APPENDIX

COMMENT ON THE EA AND RESPONSES

PEPC Correspondence  
Keep Private: Yes  
Date Received: 12/2/11

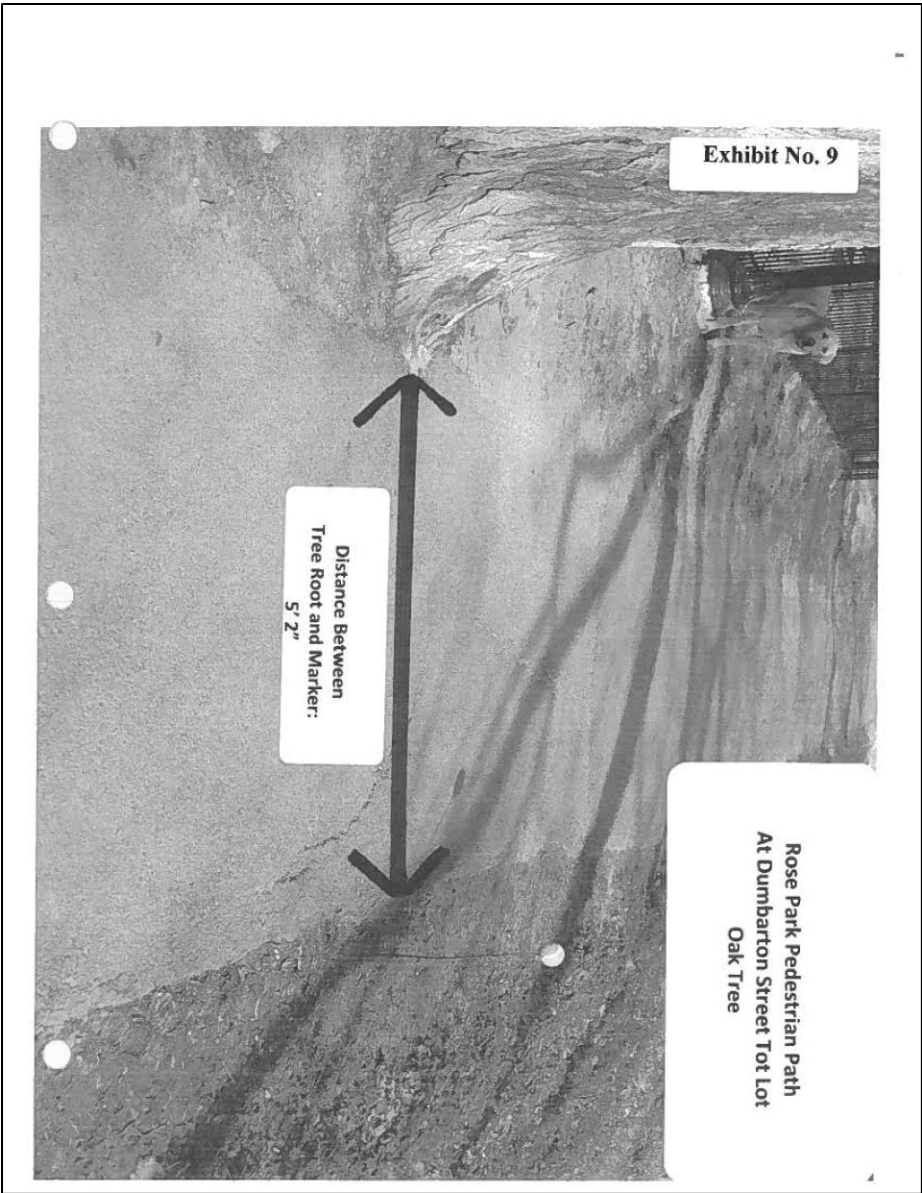
**Response to 32-32**

The suggested trail resources and construction are outside the scope of the proposed trail rehabilitation. For the Rose Park trail, signage would be considered during design of the trail rehabilitation to promote safety. NPS and DDOT determined that widening of the Rose Park trail was necessary based on field observation and trail counts in order to accommodate all users. Minimum requirements for multi-use trail facilities involve a trail width of eight feet, for short distances under physical constraints. In consideration of comments received from the Friends of Rose Park, NPS and DDOT propose a six-foot width to resolve concerns.

Under the preferred Rose Park trail option, the trail would be resurfaced to a width of six feet - the standard width of a DDOT residential sidewalk. The
